Currituck County

RESTORATION HORSE 00

ADDENDUM 1

FENCE SECTION NEAR BEACH ACCESS RAMP

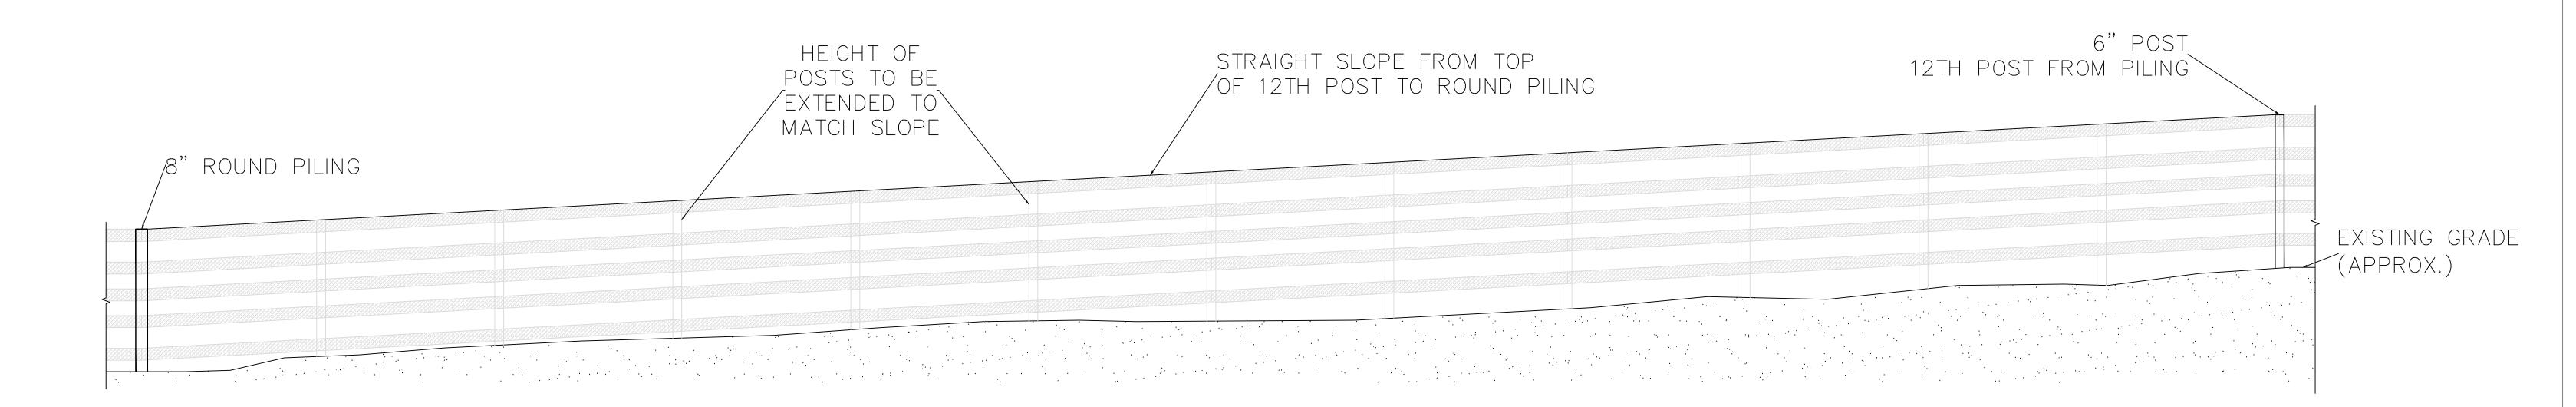
- 1. THIS SECTION IS NEAR THE BEACH ACCESS RAMP BETWEEN THE 8" ROUND PILING TO THE 12TH 6" \times 6" SQUARE POST.
- 2. THE HEIGHT OF THE 12TH POST WILL DICTATE THE SLOPE OF THIS FENCE SECTION. HEIGHT OF 12TH POST WILL BE EXTENDED TO A HEIGHT OF ± 8 ' ABOVE EXISTING GRADE.
- 3. A STRAIGHT SLOPE ALONG THE TOP OF THE THIS FENCE SECTION WILL BE FROM THE TOP OF THE 12TH POST TO THE TOP OF THE ROUND PILING.
- 4. HEIGHT OF POSTS IN BETWEEN WILL BE EXTENDED UP TO MATCH THE DESIRED SLOPE.
